**VISTA RIDGE**

LOT 16

TITLE: **REVISED PERCOLATION CERTIFICATION PLAN**

RE: 2045 Drovers Lane  
Cooksville, MD 21723  
**Perc Cert & BAT Plan**

<b>VISTA RIDGE</b> LOTS 15 AND 16	
LOCATION:	TAX MAP No. 8 - GRID No. 23 PARCEL No. 176 4th ELECTION DISTRICT HOWARD COUNTY, MARYLAND
TITLE:	<b>REVISED PERCOLATION CERTIFICATION PLAN</b>
DATE:	APRIL, 2016 SEPTEMBER, 2016
SCALE:	1" = 50'
PROJECT NO.	1490
DRAWING	1 OF 1

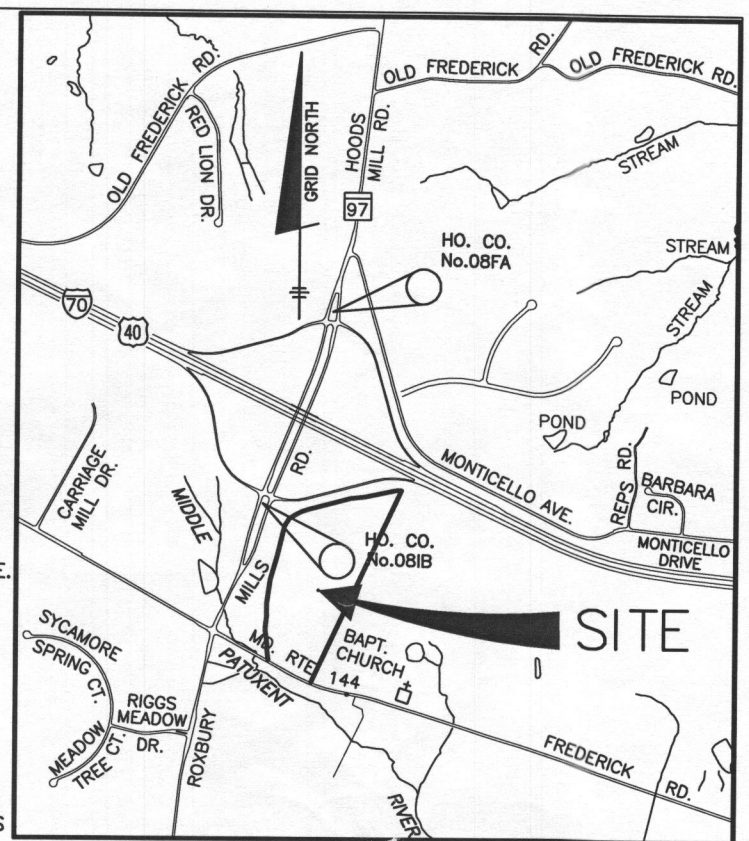
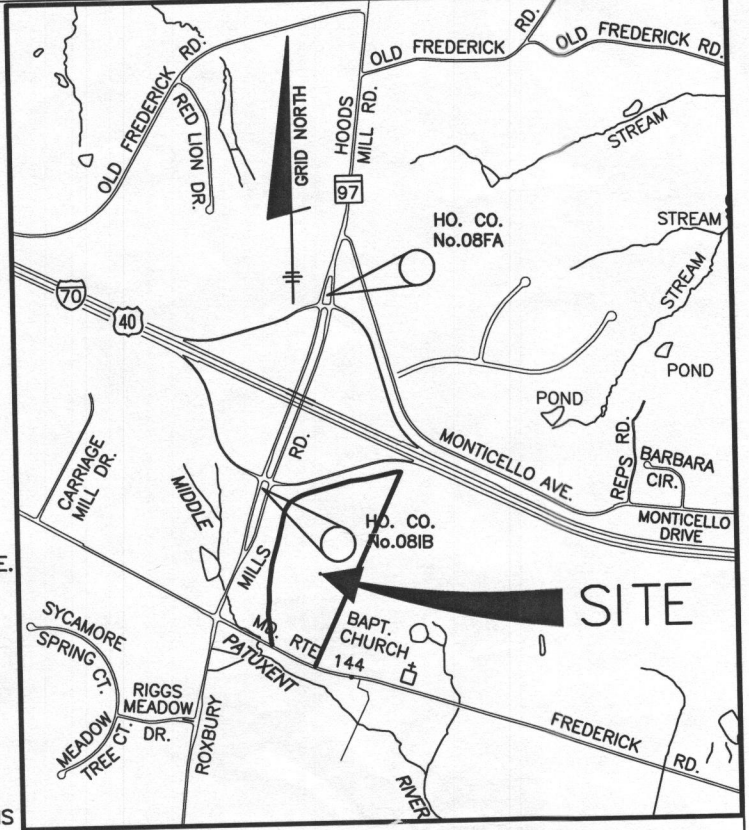
The Perc Cert and BAT Plan for 2045 Drovers Lane have been approved by the Health Dept. (10/18/16). We still need a Revised Plot Plan before this building permit can be approved. The Well Box, SDA and Grading are different from the Revised plot plan of 9/22. I have attached an email that was sent on 10/18. Let me know if you have any questions or concerns. Thanks.

We've approved the perc cert plan and BAT plan for lot 16, but we realized that the building permit plot plan doesn't show the same building footprint or any of the updated SDA/septic component info on it. Please revise the plot plan and upload to Accela. Send an email to me and Spencer (Robert Freemon, copied on this email) when that's done. Once we see it in Accela, we can approve the BP

- 1 • On the Perc Cert the SRA does not contain the 10,000sqft required. The portions being added and removed create a total of 9989sqft. In order to get the 10,000sqft one suggestion could be to keep the northern half of the labeled "Removal from S.R.A." portion. Another suggestion could be to add a small portion of SRA to the west side of Perc Hole 35 along contour.
- 2 • The Perc Cert note #5 needs to state who field verified the topography.
- 3 • In the Perc Cert Notes there needs to be a purpose statement for the Perc Certs revision.
- On the BAT plan the effective area is not between 6-8 feet. According to the spec sheet the effective area starts at 7 feet and ends at 8 feet.
- The BAT Plan does not have all of the required notes. I have attached the BAT Site Plan Requirements for your review.

- 9.) THE PURPOSE OF THIS PERCOLATION CERTIFICATION REVISION IS TO REMOVE THE LOT 15 1500 SF WELL BOX, SHOW A DRILLED WELL AND TWO ALTERNATIVE LOCATIONS ON LOT 15 AND TO REVISE THE LOT 16 SEPTIC DISPOSAL AREA.

✓ Robert, the perc cert comment 1 was a mislabel on the area that was being removed. We were removed and added equal areas, just the text was wrong. It looks like the area will have to change anyways.

✓ Comment two, we have field verified the topo so I adjusted the note to reflect this.

✗ Comment 3 was addressed by adding note 9. *Added to BAT Plan not Perc Cert*

Comment 4 about the effective area is a major issue. Looking at the notes we have 1.5 or 2 foot of effective area for the upper holes (P-39 and P-74) but I see the concern about the same amount in the lower holes. I have some solutions that may require the well box to be adjusted and an alternative well site added. Attached are the computations and a sketch on the BAT plan, I will finish revising the piping and tank design etc. when we decide about the trench layout. If you could take a look I would appreciate it. We should discuss this over the phone. Trench 1-1 is 70', Trenches 1-2 and 1-3 are both 77'. Trenches 2-1, 2-2 and 2-3 are 86.7'. Trenches 3-1, 3-2, 3-3, 3-4 and 3-5 are 52'. Trench 3-5 is below the old bottom of the SRA.

✓ Comment 5 - The BAT site plan notes are already on page 2, please double check and verify. *Verified on 2nd Page*
